Piper Aircraft, Inc.
2926 Piper Drive
Vero Beach, FL, U.S.A. 32960

SERVICE NO. 1229 LETTER

Date: January 3, 2019

CONTROL QUADRANT INSPECTION

Figure 1
Control Quadrant Assembly With Cover Removed

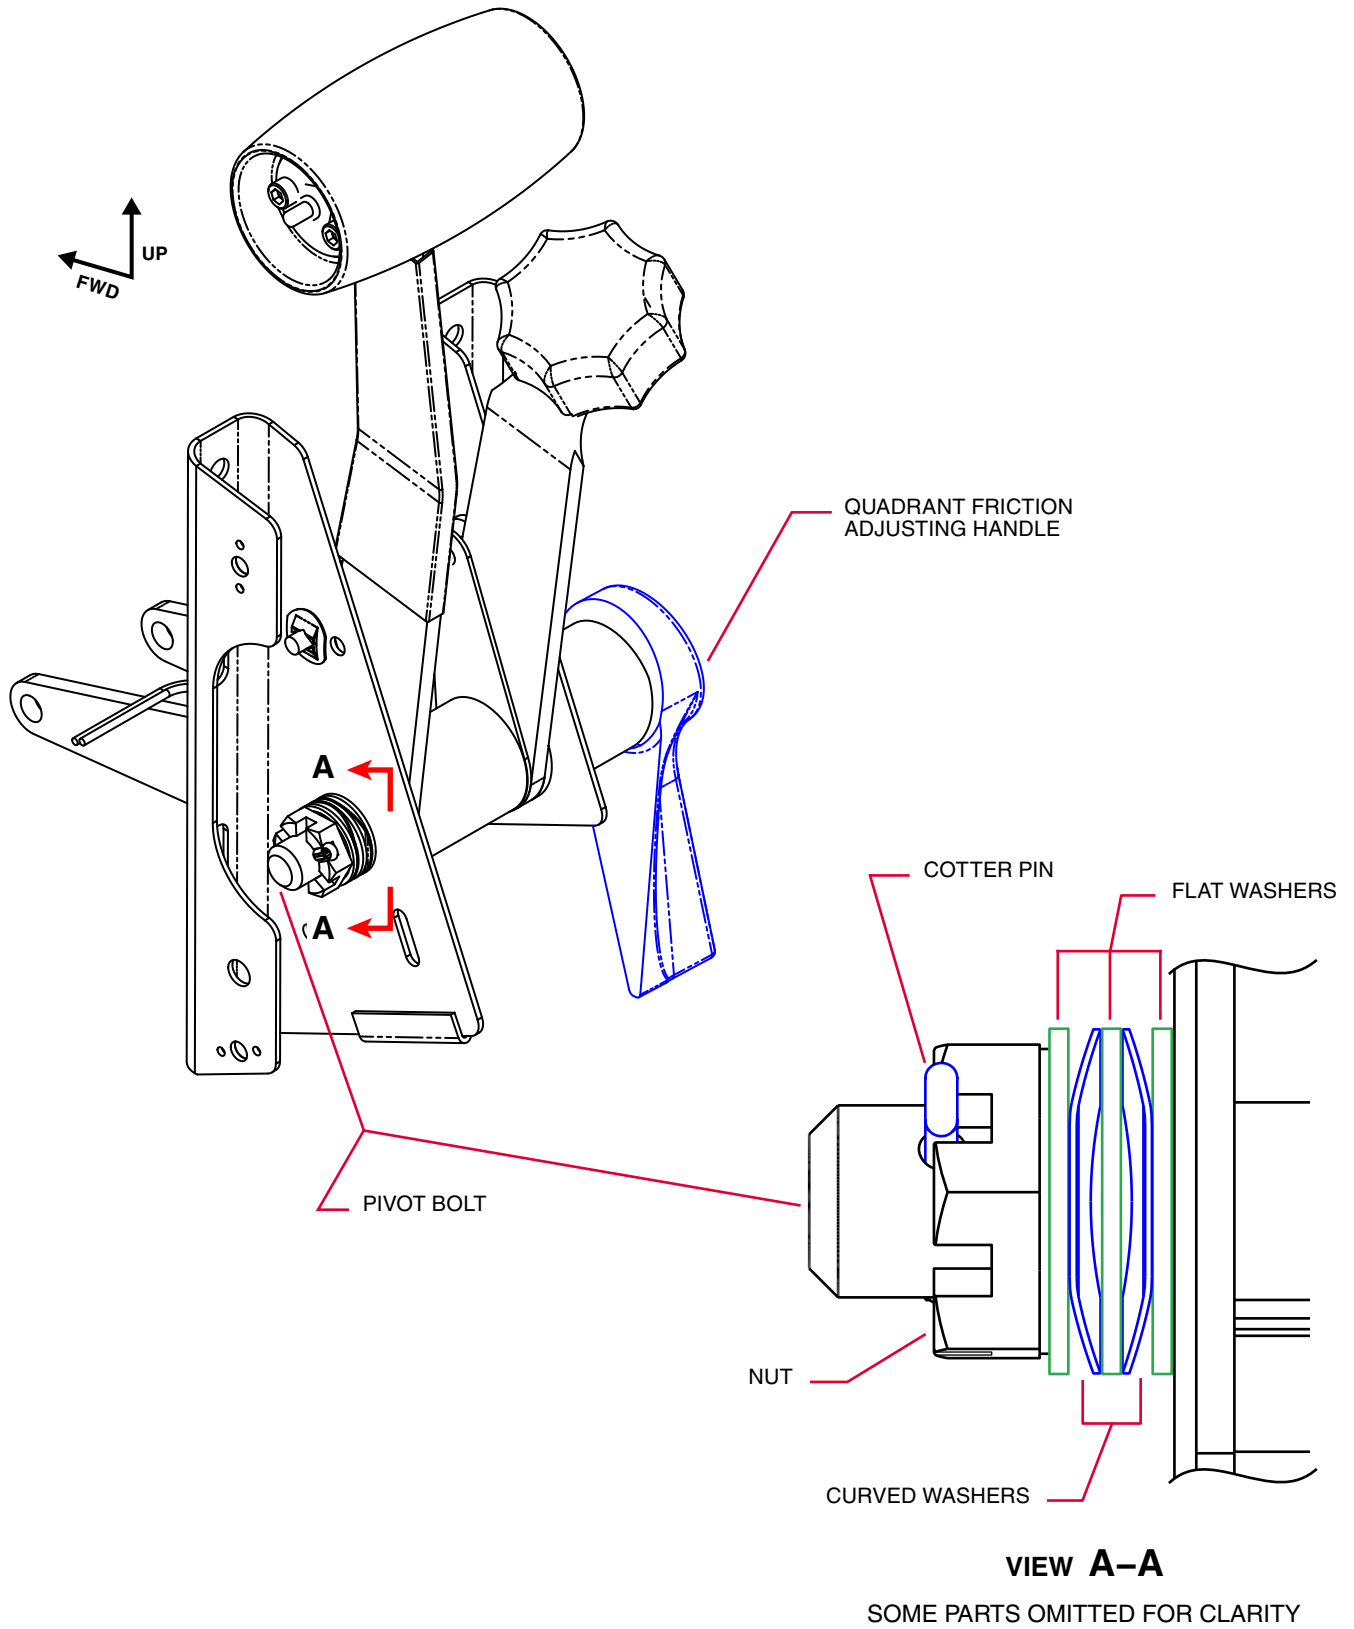
4. Inspect the bolt that the levers pivot around and locate the stack of five (5) washers at the end of the bolt.
5. Compare the washer stack to Figure 1. There should be two (2) curved washers and three (3) flat washers. The configuration of these washers (their order, and the direction of the curved washers) must match the configuration shown in Figure 1.

6. If the stack of washers does not match Figure 1:

- Remove the cotter pin and nut from the end of the bolt. Retain the nut; discard the cotter pin.
- Rearrange the washer configuration to conform to Figure 1.
- As required to attain the proper, spring-loaded operation of the adjusting handle, add more flat washers on either side of this five (5) washer combination.

- Reinstall the washers and nut; install a new cotter pin at the end of the bolt. (Refer to Figure 1.)
